UNITED STATES PATENT AND TRADEMARK OFFICE

APPLICATION NO.	FILING DATE	FIRST NAMED INVENTOR	ATTORNEY DOCKET NO.	CONFIRMATION NO.
10/083,660	02/27/2002	Jose Carlos Carvalho Veiga	33975R002	9469

Office Action Summary

DETAILED ACTION

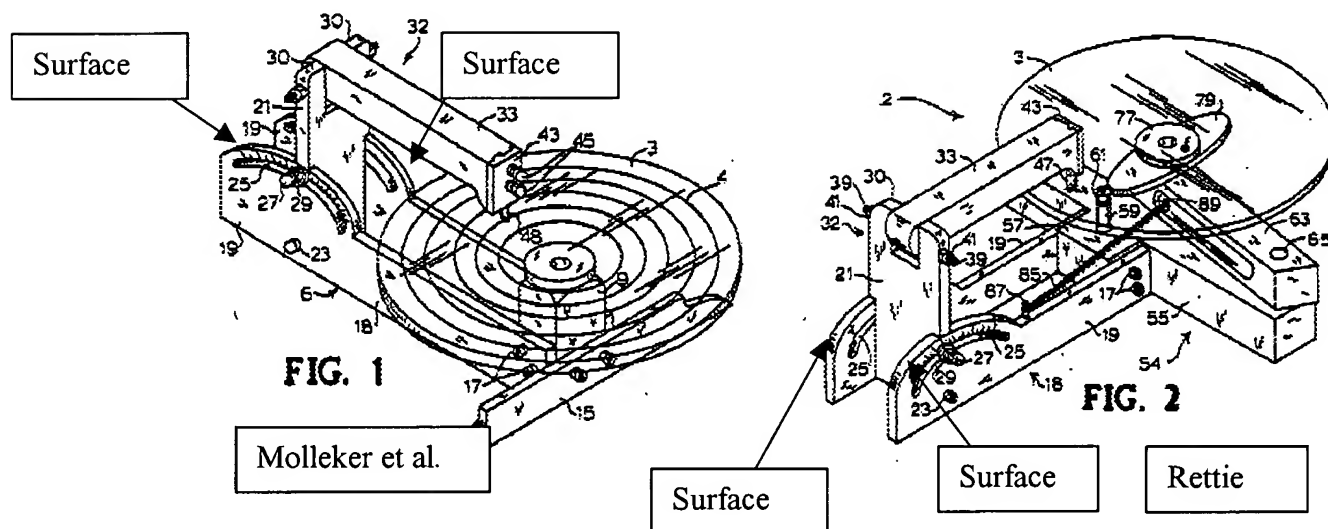
Regarding claim 19, as illustrated in the indicated reproduced figures, both the device taught by Molleker and the device taught by Rettie have “the claimed “surfaces” that support “rods” 21, which rods 21 each support the cutting blades.

Regarding claim 20, note that pivot screws 23 serve to “attach” the support rods 21 to their respective “platforms”, pivot screws 23 are “fixed in relation” to the “platform”, and that the rods 21 are “mobile” in relation to the screws 23 in that they pivot about them to enable the

cutter blades to be moved towards and away from the turntables 3 (see Figures 1-2), and thus the pivots 23 are considered the “support” as claimed.

Regarding claim 23, as best understood, the pivot members 23 are attached by “bolts” to the “platform”. Additionally, the “turntables” are also ultimately connected to the “platform” by “bolts” such as 17 (Figure 2 of both references).
